**REGION 8**

Doug Martin
Acting NRDP Program Manager
EPA Response to NRDP Comments
Montana NRDP
Helena, MT 59620

Re: The EPA's Response to NRDP Comments on EPA's Position on the Use of Onsite Material as General Fill at Butte Priority Soils Operable Unit of the Silver Bow Creek/Butte Area Superfund Site.

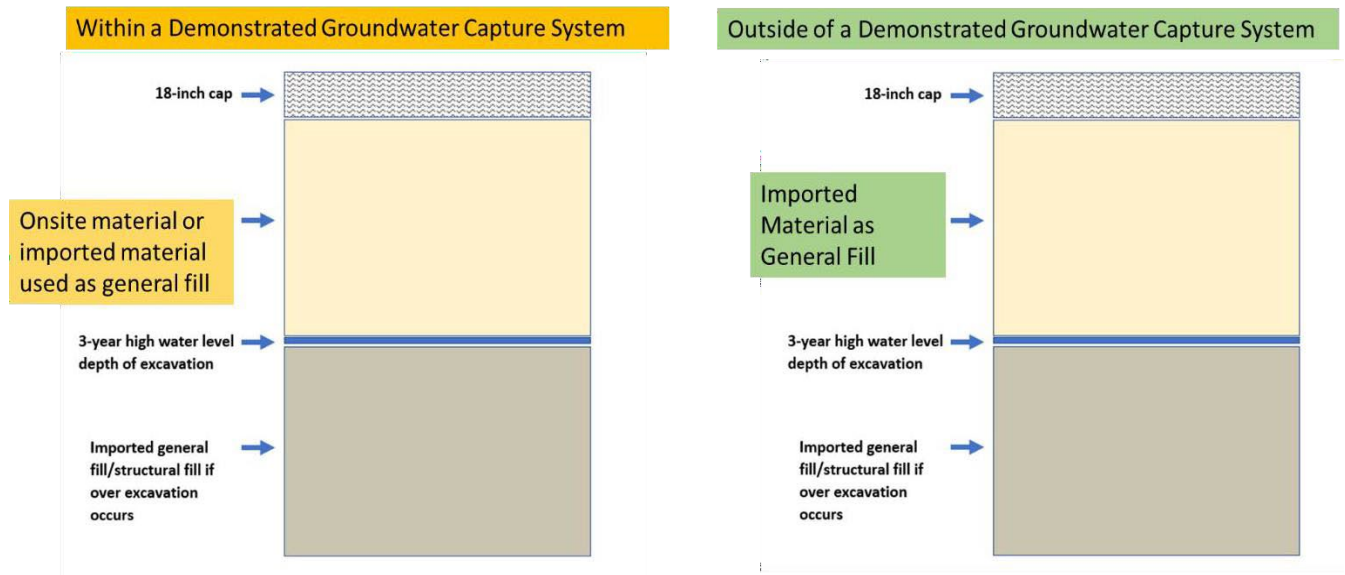
We recommend providing the source of this statement in a reference or preferably delete this sentence. Maximum thresholds for contaminant concentrations for solid materials/soils and water should be set at levels that are protective of human health and the environment; protection of the environment should not rely on an assumption that the contaminants will be significantly below the allowed levels.

NRDP previously received the data that is the basis for the EPA’s statement regarding the metals concentrations in the “[Draft Final Butte Priority Soils Operable Unit \(BPSOU\) Northside Tailings/East Buffalo Gulch Area and Diggings East Stormwater Basin Area Further Remedial Element 30% Remedial Design](#)” and the “[60% Draft Buffalo Gulch Stormwater Basin Remedial Design Report](#).” These were provided to all CD parties by AR in December 2020 and December 2022, respectively.
